17DK SEAL LEAK POT ASSEMBLY

C9013  
7/16/90  
NONE

17DK/DM Compressor

Purpose: This bulletin provides information on the redesigned seal oil pot assembly.

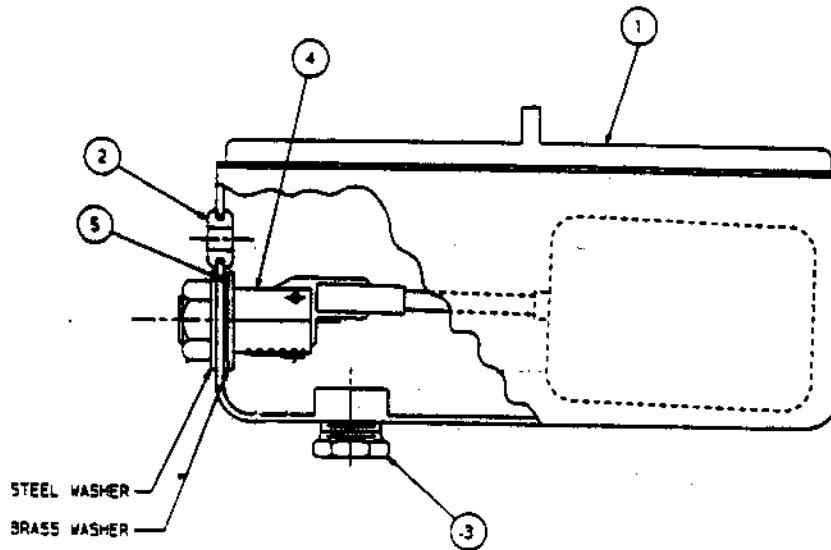
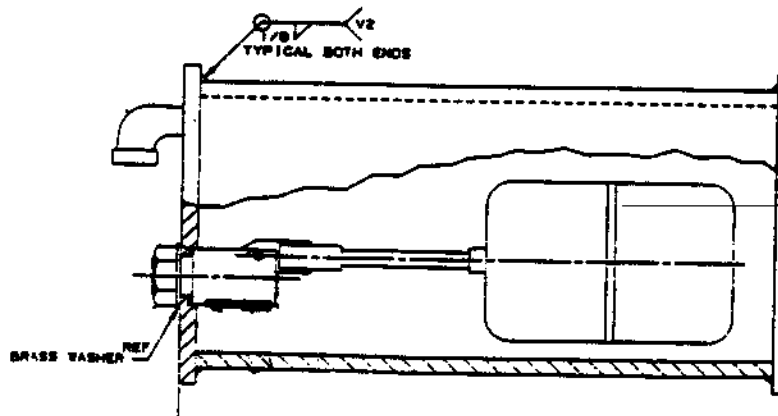
Background: The old style seal pot 17DK 111-123 was built from 4" sch. #40 pipe with end plates welded. Therefore, there was no access to the valve and float assembly. The new style 17DR 501-213 has a removable lid for easy access. See attached figure 1. The change went into effect March 1989.

Recommendations: If the item 4 valve leaks, in the old type seal pot assembly, the entire assembly should be replaced with the new style pot.
